CCB 7273

Pre and Post Change Summary

PCN #: DSNO-13ILTQ928

LEAD-FRAME COMPARISON

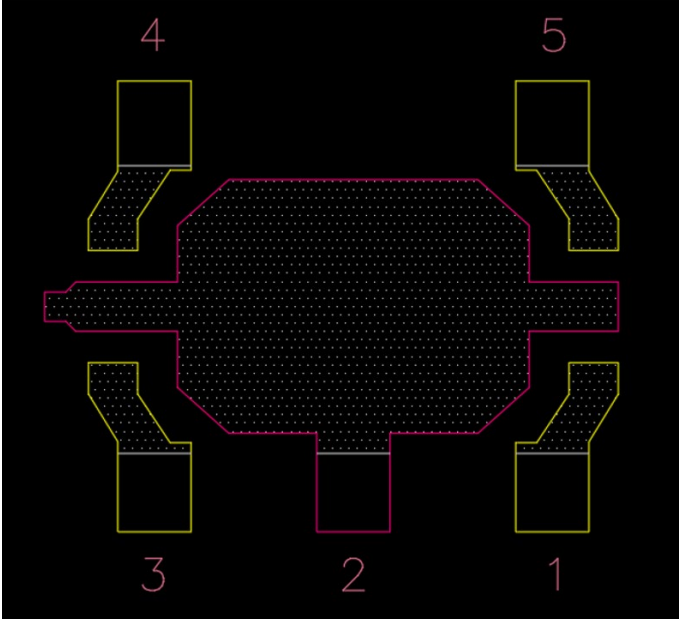
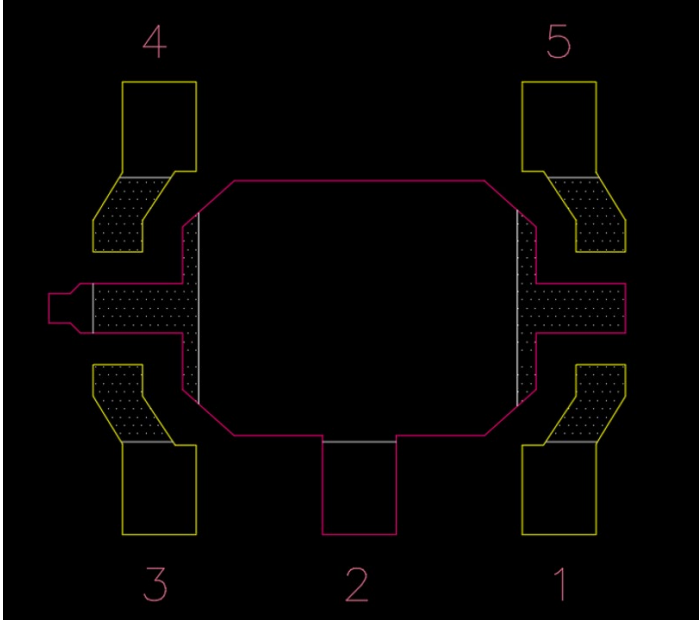
<p><i>Note: Not to scale</i></p>	<p><i>Note: Not to scale</i></p>												
<table border="1"> <tr> <td>Wire Material</td> <td>Au</td> </tr> <tr> <td>Lead-Frame Material</td> <td>CDA194</td> </tr> <tr> <td>DAP Surface Prep</td> <td>Ag Spot Plated</td> </tr> </table>	Wire Material	Au	Lead-Frame Material	CDA194	DAP Surface Prep	Ag Spot Plated	<table border="1"> <tr> <td>Wire Material</td> <td>CuPdAu</td> </tr> <tr> <td>Lead-Frame Material</td> <td>A194</td> </tr> <tr> <td>DAP Surface Prep</td> <td>Ag Single Ring Plated</td> </tr> </table>	Wire Material	CuPdAu	Lead-Frame Material	A194	DAP Surface Prep	Ag Single Ring Plated
Wire Material	Au												
Lead-Frame Material	CDA194												
DAP Surface Prep	Ag Spot Plated												
Wire Material	CuPdAu												
Lead-Frame Material	A194												
DAP Surface Prep	Ag Single Ring Plated

Note: C194, A194 or CDA194 Lead frame material are the same, it is just a MCHP internal labelling difference.
